**An Evaluation of Flood Frequency Analyses for the Skagit River,
Skagit County, Washington**

**Federal Emergency Management Agency
Region X
Bothell, Washington**

**February 26, 2010
Revised May 19, 2010**

Purpose of this Review

Figure 2. Flood frequency curve for regulated peak discharges observed by USGS at Concrete compared with the HEC-RAS simulated regulated peak flows at Concrete (Figure 21 from PIE (2008)).

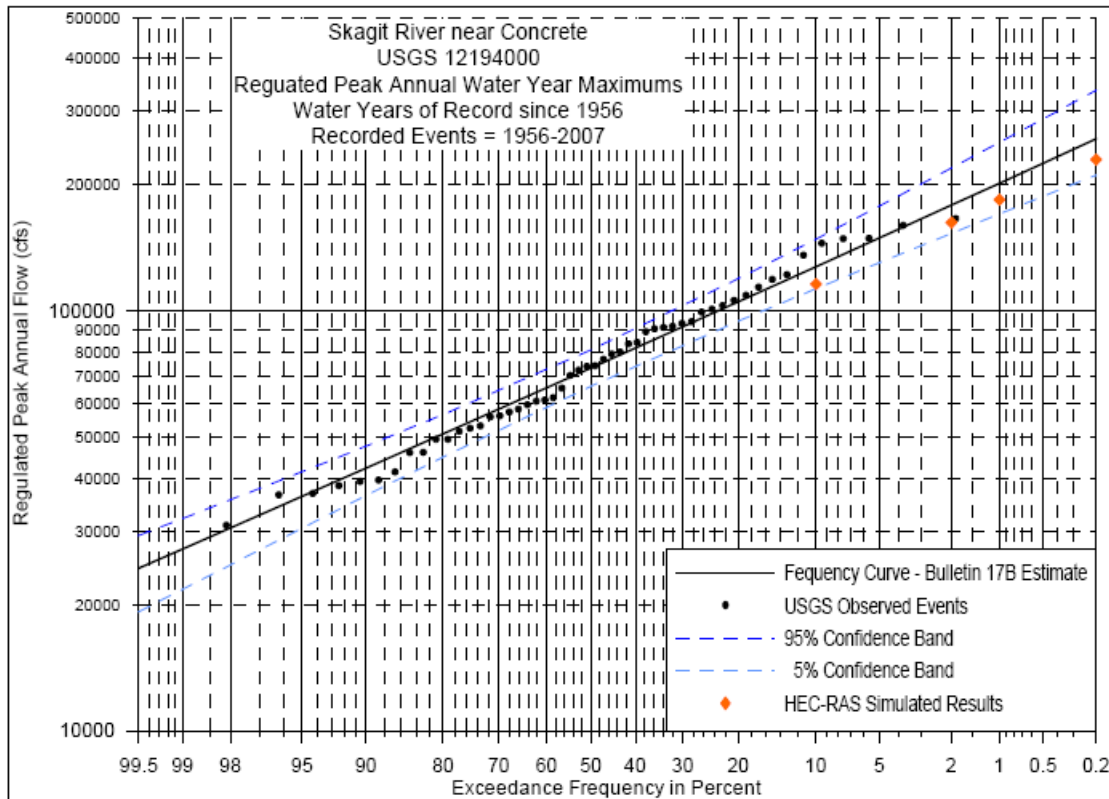
The HEC-RAS routed flows in Figure 2 for the 10-, 2-, 1- and 0.2-percent chance floods are less than the regulated frequency curve based on the observed record from 1956 to 2007. The unregulated flood hydrographs that were routed to give the HEC-RAS simulated results in Figure 2 were based on the four historic floods and other unregulated peak data from 1925 to 1955. The PIE (2008) estimates of the four historic floods have been significantly reduced from those published by USGS and their impact on the regulated frequency curve is now minimal.

Figure 3. Comparison of unregulated and regulated frequency curves for the Skagit River near Concrete, WA as developed by PIE (2008).

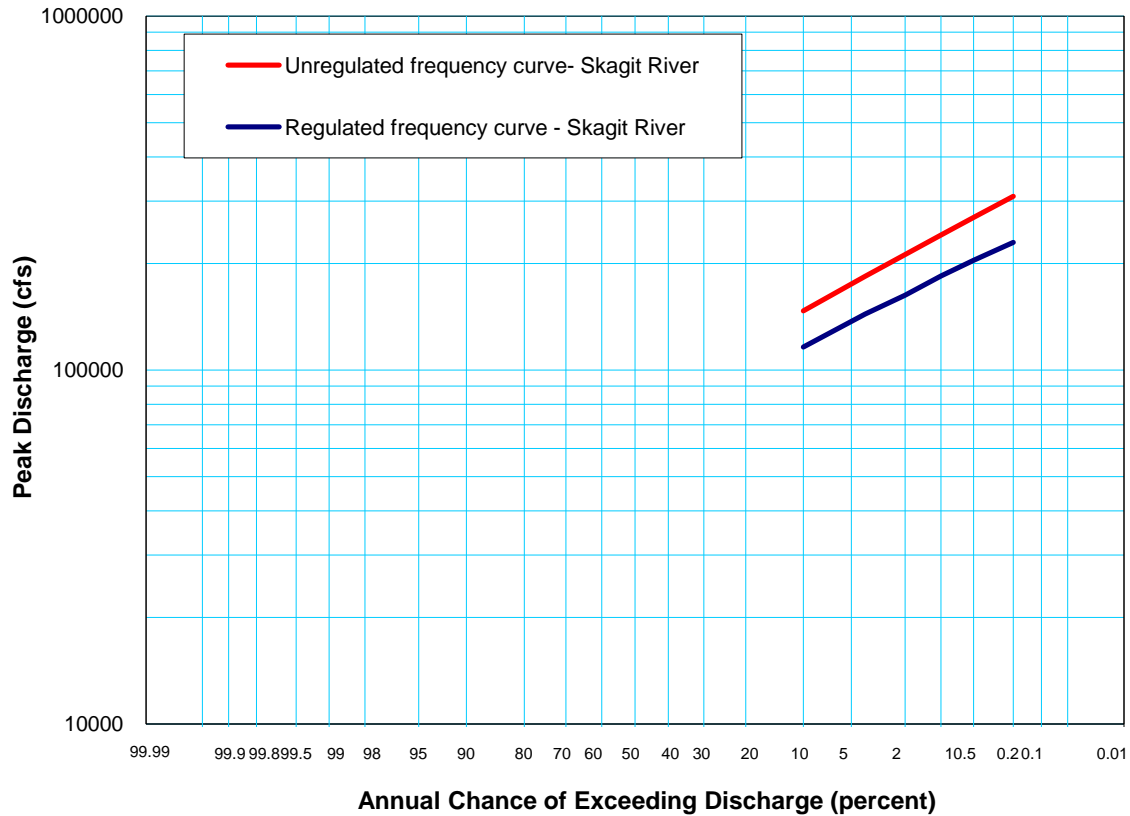
As shown in Table 3, the ratio of the regulated to unregulated flood discharges for the PIE analysis is actually decreasing as the flood event becomes more extreme while the USACE ratio increases as it should. As the magnitude of the flood event increases and the flood storage in the reservoirs decreases, the regulated and unregulated flood discharges should converge. At the 0.2-percent annual chance event, the PIE (2008) unregulated and regulated frequency curves are still diverging. This is illustrated in Figure 3. The skew for the PIE (2008) regulated frequency curve is about -0.35 and -0.142 for the unregulated curve implying they are diverging.

The diverging of the regulated and unregulated frequency curves was prevalent in an earlier 2005 analysis performed by PIE. This issue was discussed in a February 2006 review by FEMA. In response to the FEMA 2006 review, PIE pointed out that their 2005 frequency curves would converge at about 4 times the 1-percent annual chance flood discharge. This may also be the case for the PIE (2008) analysis that the frequency curves will converge for some very large flood event. However, it seems the PIE (2008) regulated and unregulated frequency curves should be converging for a large flood like the 0.2-percent chance flood given the dedicated flood storage (71 acre-feet per square mile) in the Skagit River watershed.

Figure 4. Comparison of unregulated and regulated frequency curves for the Skagit River near Concrete, WA as developed by USACE (2008).

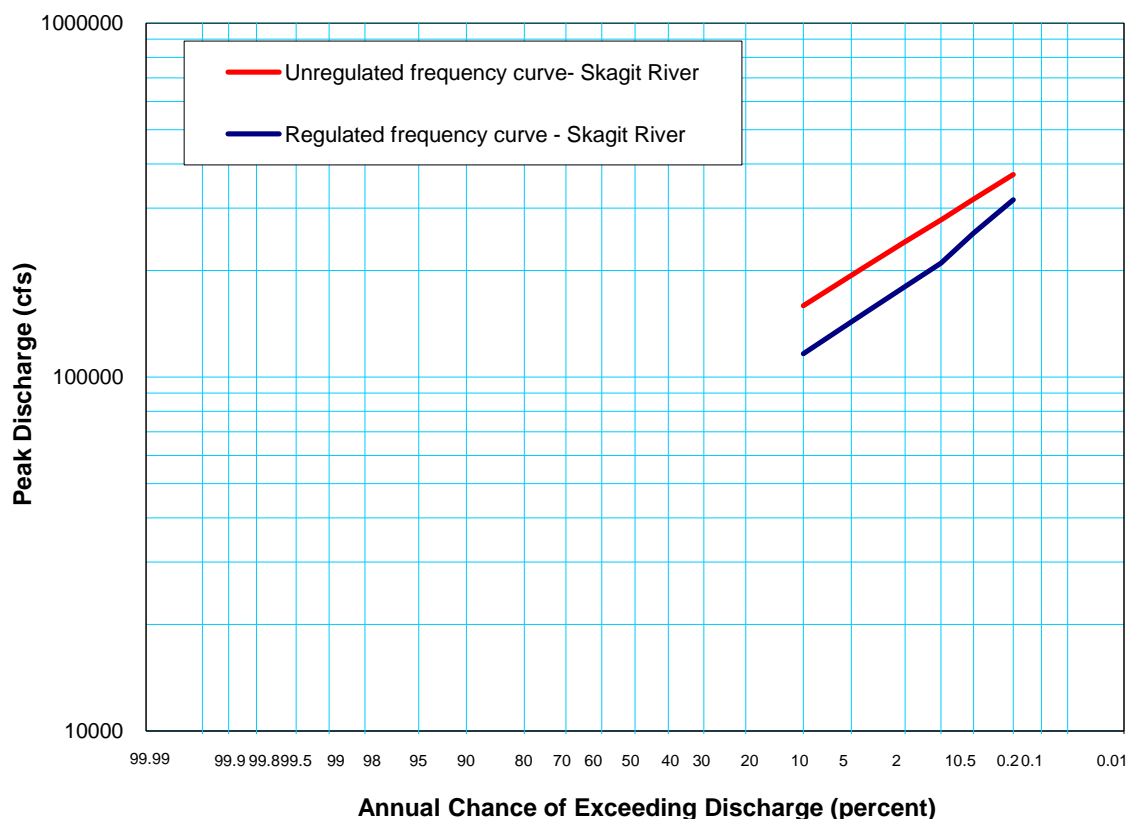
This is the case for the USACE (2008) analyses as shown in Table 3 and in Figure 4. The skew for the USACE (2008) regulated frequency is about 2.0 and 0.0 for the unregulated curve implying the frequency curves are converging.
